IN THE DRAWINGS

FIGURE 1

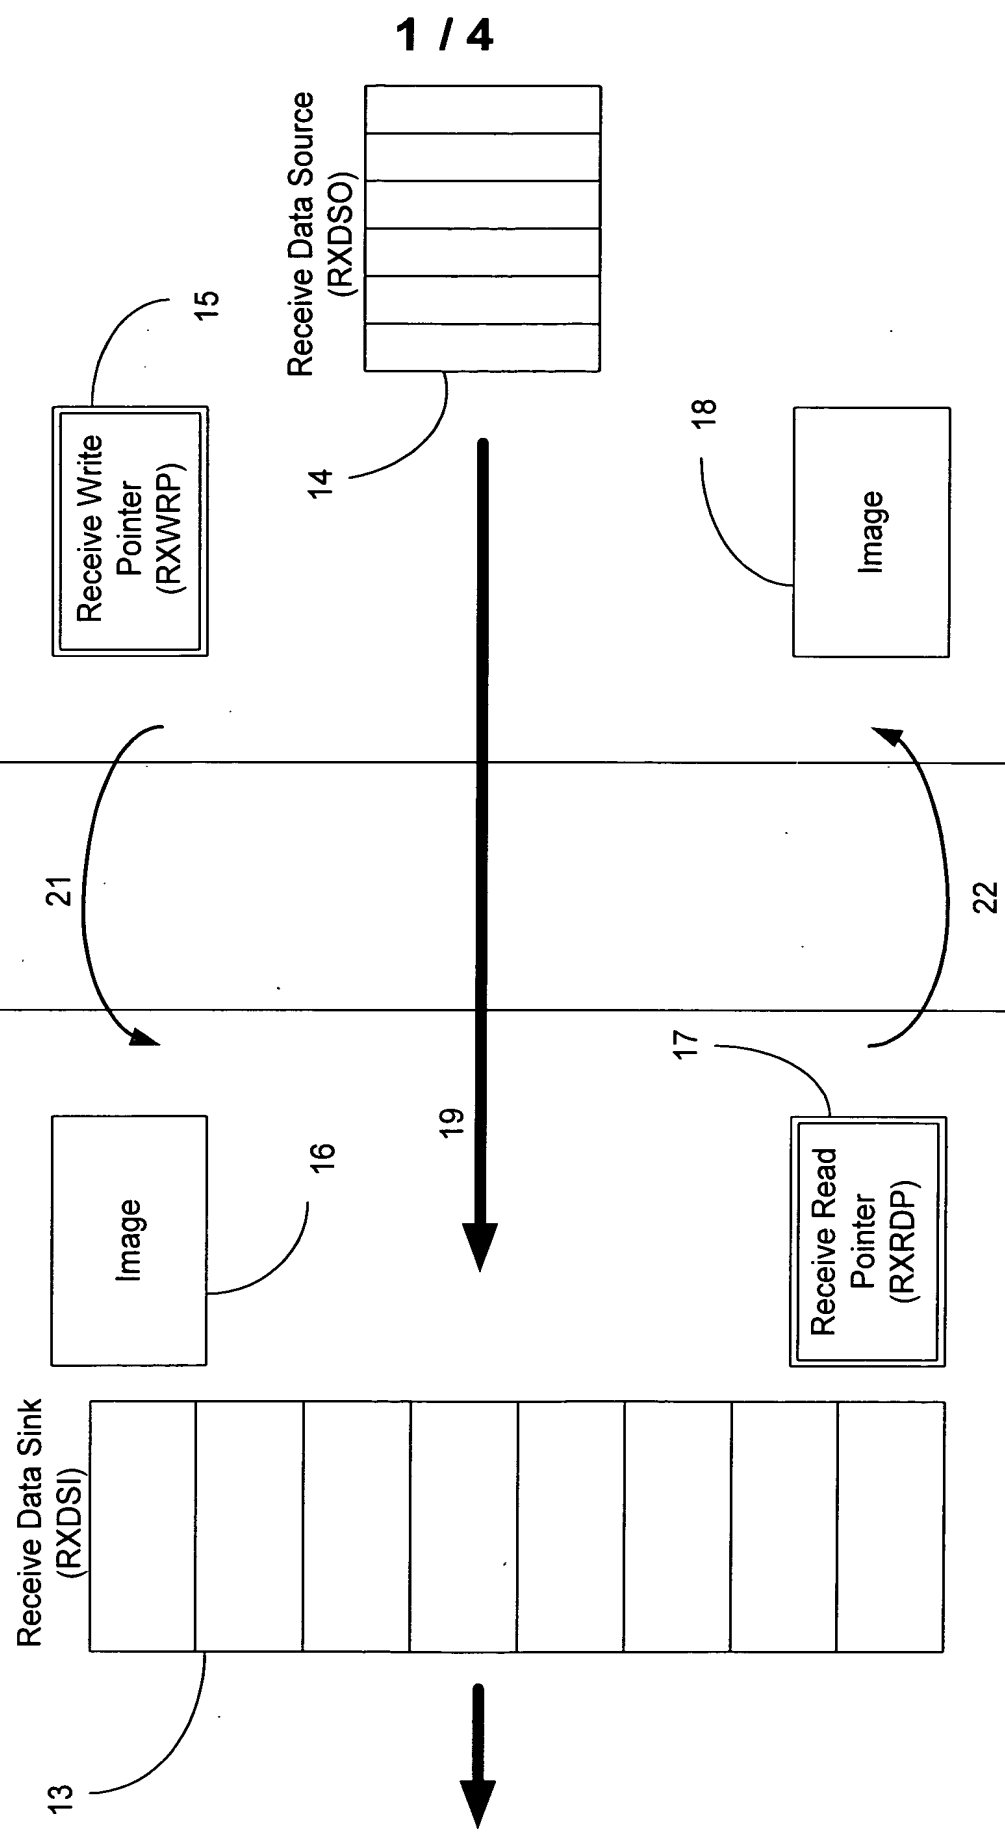
✓ The Examiner objected to the drawings, requiring labels for various reference characters in Figures 1-4. In response to the Examiner's objections, labels have been added to Figure 1-4 to address the Examiner's concerns. A proposed drawing correction is provided herein. Applicants respectfully assert that no new matter has been added as a result of the amendments to the drawings.
